Access Compliance Report

Public Rights-of-Way

(Island Curb Cuts)

Intersection ID: 53165	Main Street: DIXIE_RIVER_RD	Cross Street: STYLE_LN	Location: N
ADA ID: 773F5A3E4E02	Curb Cut Type: MedianRefuge2	Initial Pass/Fail: Fail	Overall Compliance: No
Severity Score: 0			
Codes/Mitigation Info/Possible Solution		Field Measurements/Component Compliance

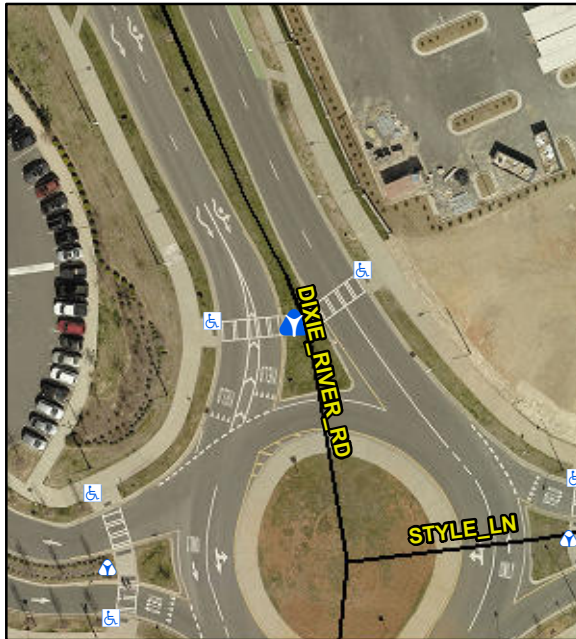
Compliance	Description	Data	Compliance	Description	Data
Yes	Refuge 1 Length (In)	102	N/A	Gutter 1 Ponding?	N/A
Yes	Refuge 1 Width (In)	114	N/A	Gutter 1 Lip Ht (In)	N/A
Yes	Refuge 1 Slope (%)	0.3	N/A	Gutter 1 Slope (%)	N/A
Yes	Refuge 1 X Slope (%)	3.5	N/A	Gutter 1 X Slope (%)	N/A
N/A	Painted X Walk1?	Yes	N/A	DWS 1 Provided?	N/A
N/A	X Walk 1 Direction	To W	N/A	DWS 1 Contrast?	N/A
N/A	X Walk 1 Width (In)	112	N/A	DWS 1 Length (In)	N/A
N/A	Road 1 Slope (%)	3.8	N/A	DWS 1 Full Width?	N/A
N/A	Road 1 X Slope (%)	4.1	N/A	DWS 1 Offset (In)	N/A
Yes	Refuge 2 Length (In)	102	N/A	Gutter 2 Ponding?	N/A
Yes	Refuge 2 Width (In)	114	N/A	Gutter 2 Lip Ht (In)	N/A
Yes	Refuge 2 Slope (%)	0.3	N/A	Gutter 2 Slope (%)	N/A
Yes	Refuge 2 X Slope (%)	4.6	N/A	Gutter 2 X Slope (%)	N/A
N/A	Painted X Walk2?	N/A	N/A	DWS 2 Provided?	N/A
N/A	X Walk 2 Direction	To NE	N/A	DWS 2 Contrast?	N/A
N/A	X Walk 2 Width (In)	111	N/A	DWS 2 Length (In)	N/A

N/A	Road 2 Slope (%)	6.0	N/A	DWS 2 Full Width?	N/A
N/A	Road 2 X Slope (%)	1.8	N/A	DWS 2 Offset (In)	N/A
N/A	Refuge 3 Length (in)	N/A	N/A	Gutter 3 Ponding?	N/A
N/A	Refuge 3 Width (in)	N/A	N/A	Gutter 3 Lip Ht (in)	N/A
N/A	Refuge 3 Slope (%)	N/A	N/A	Gutter 3 Slope (%)	N/A
N/A	Refuge 3 XSlope (%)	N/A	N/A	Gutter 3 XSlope (%)	N/A
N/A	Painted X Walk3?	N/A	N/A	DWS 3 Provided?	N/A
N/A	X Walk 3 Direction	N/A	N/A	DWS 3 Contrast?	N/A
N/A	X Walk 3 Width (in)	N/A	N/A	DWS 3 Length (in)	N/A
N/A	Road 3 Slope (%)	N/A	N/A	DWS 3 Full Width?	N/A
N/A	Road 3 XSlope (%)	N/A	N/A	DWS 3 Offset (in)	N/A
Yes	Any Obstructions?	N/A	N/A	Storm Grate/Utility Hazard?	N/A
N/A	Obstruction Type		N/A	Storm Grate/Utility Type	
		N/A			N/A
N/A	Surface Condition	N/A

Remove & Replace Entire Refuge.
